SATTERLEY PTY LTD SUBMISSION TO LINDUM VALE PSP EXHIBITION

OCTOBER 2017

Figure 4: Consultation draft of Future Urban Structure annotated by Alluvium

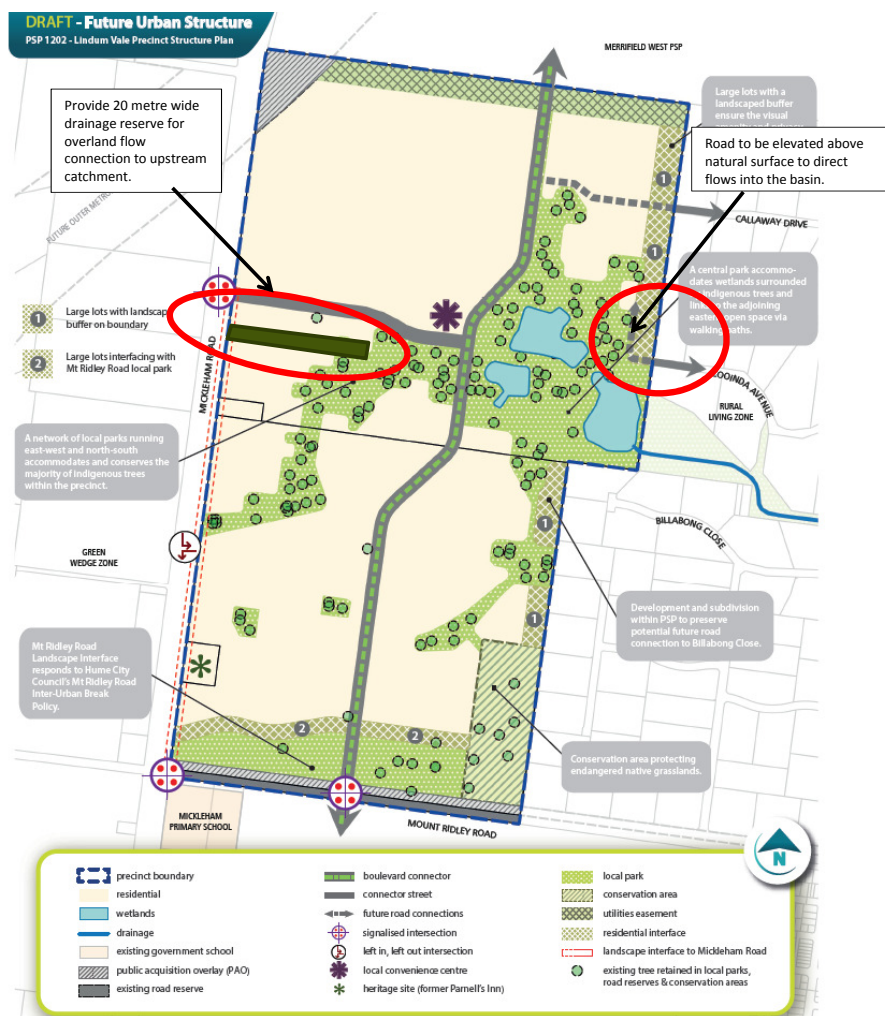
- *The existing outfall constraints and characteristics need to inform the future surface water management strategy for the development of the Lindum Vale PSP. That is the concentrated outflows from the developed catchment should not be allowed to discharge into adjoining residential properties. As a result Alluvium's proposed surface water management strategy will collect, retard and convey all surface flows up to the 100 year ARI event to the existing drainage reserve that interfaces with the development. This would be achieved through the provision of three separate drainage reserves. That is a wetland/basin reserve in the north, a single wetland/basin reserve in the central open space area and a wetland/basin reserve in the south. However the exhibited Lindum Vale PSP only includes provision for a large central drainage reserve, which includes three stormwater quality treatment assets within the significant stand of native trees. This arrangement is not feasible based on the need to provide flood protection to adjoining allotments and the protection of existing trees from excessive earthworks (which contradict R31).*

- *The entire large central reserve as shown on the PSP is not required for drainage purposes and therefore shouldn't be considered as encumbered for drainage reasons. The primary reason for the majority of the reserve is therefore for the preservation of the trees.*

Figure 5: Proposed stormwater strategy from Alluvium report

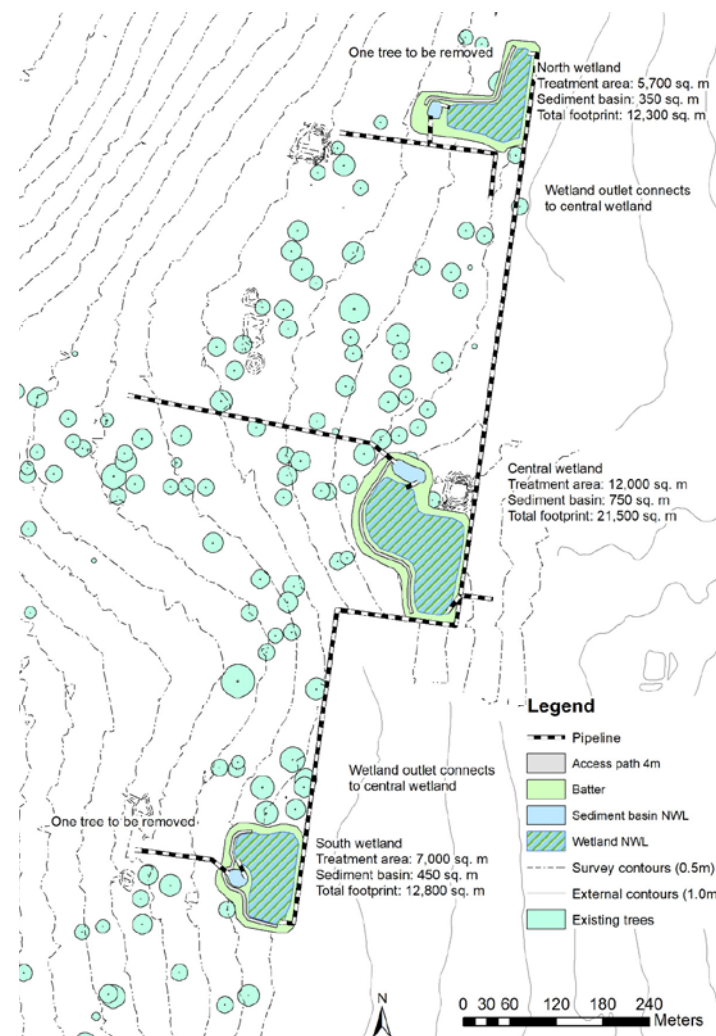
Alluvium have provided the following comments in relation to the design of stormwater drainage in the PSP area (refer also to the attached Draft Surface/Storm Water Management Strategy):

In addition to the above-mentioned recommendations is requested that land ultimately set aside for drainage purposes is identified on the gazetted zoning plan with an appropriate zone applied, rather than the General Residential Zone.

Figure 6: Classification of trees from the PSP and NVPP

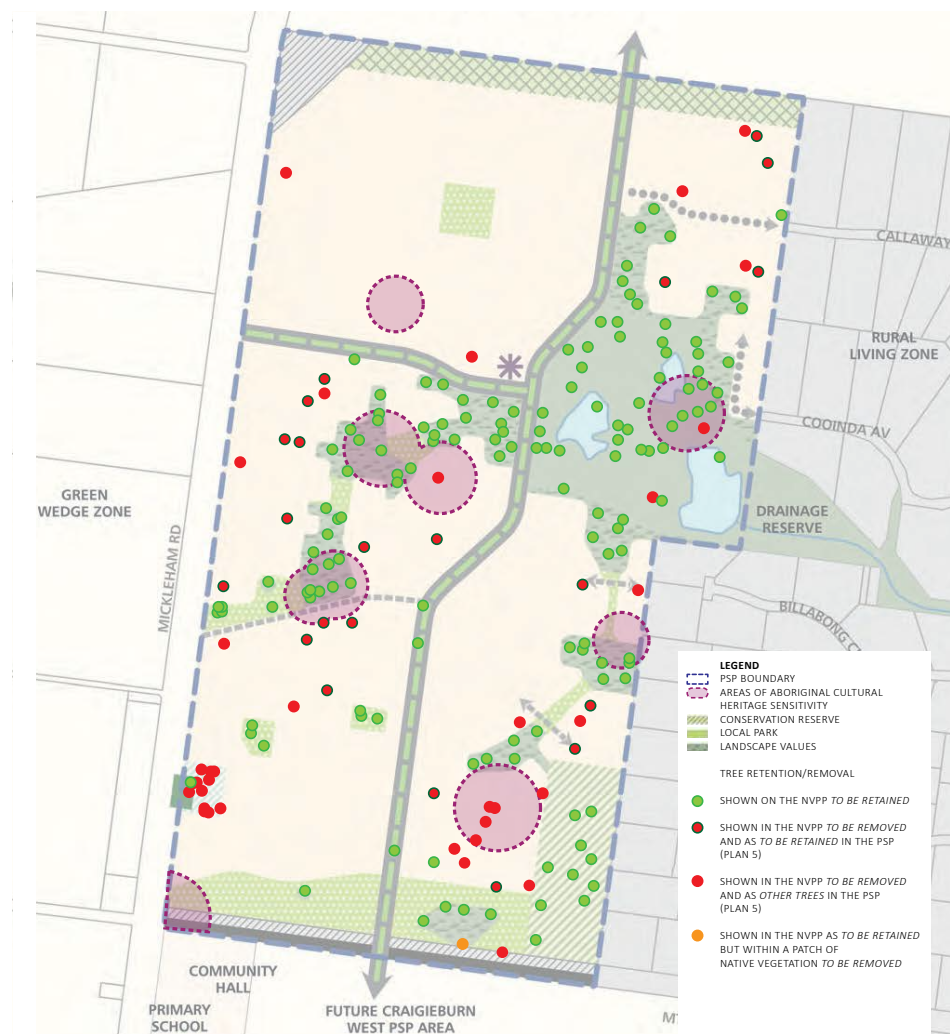
Of the 201 trees identified in the NVPP for retention or removal or identified in the PSP as having landscape values, 165 (82%) are identified for retention and we anticipate that this number will be higher when the Aboriginal scar trees are taken into account. We submit that the PSP should reduce the tree retention rate by taking a more pragmatic approach to tree retention.

There are three scattered trees shown for retention in the NVPP that are located within the connector road (trees 25, 90 and 91). These should be shown as scattered trees to be removed.
